WATER QUALITY MEMORANDUM Utah Coal Regulatory Program

RE: 2009 Fourth Quarter Water Monitoring, Canyon Fuel Company, LLC, SUFCO Mine, C/041/0002, WQ09-4, Task ID #3443

Groundwater Elevation for Well 01-8-1

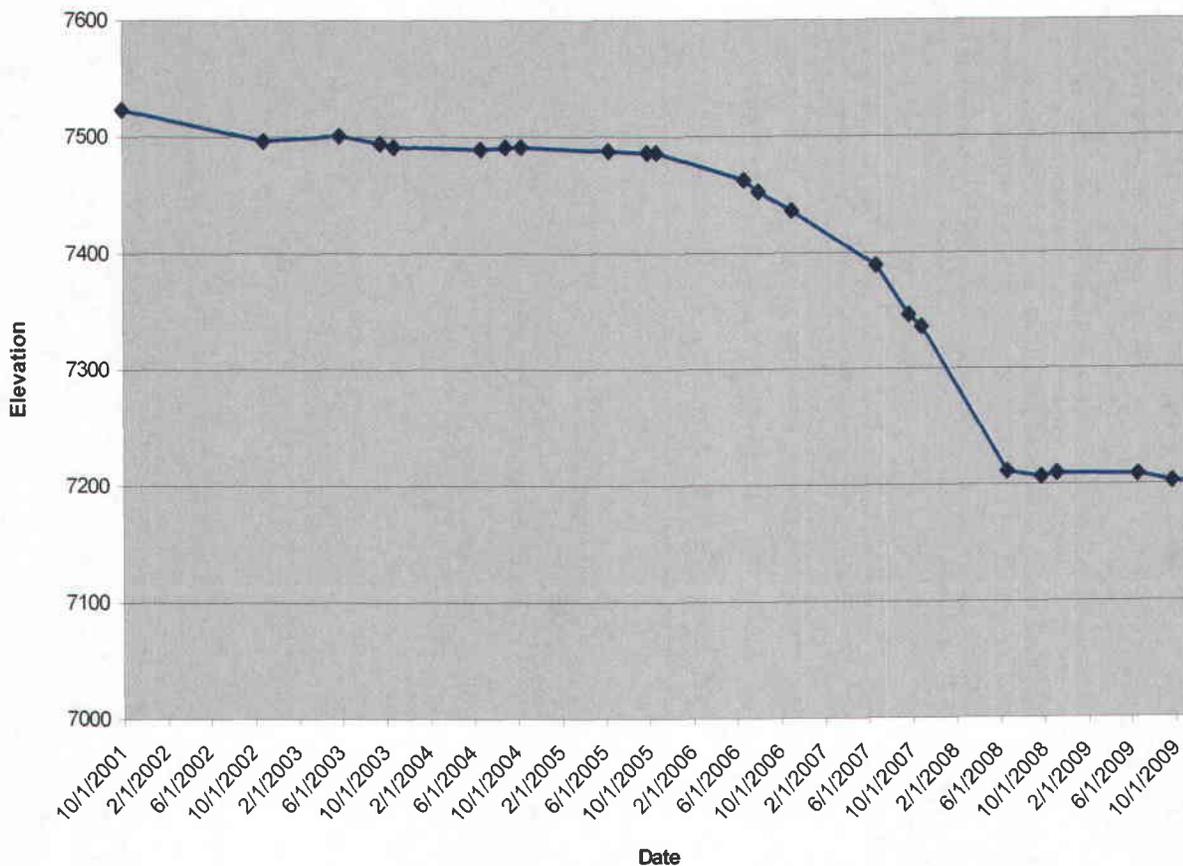
The Permittee submitted all required samples for the wells. Groundwater elevations for well 01-08-1 have been submitted since 2001 monitoring the groundwater in the SITLA Muddy Lease tract. As can be seen in the chart, there was a decline in groundwater elevations of approximately 275 feet evident from the period between October 2005 and June 2008 while this area was being actively mined. Groundwater levels have begun to stabilize but it is not apparent as of yet if groundwater elevations will rebound to pre-mining levels.
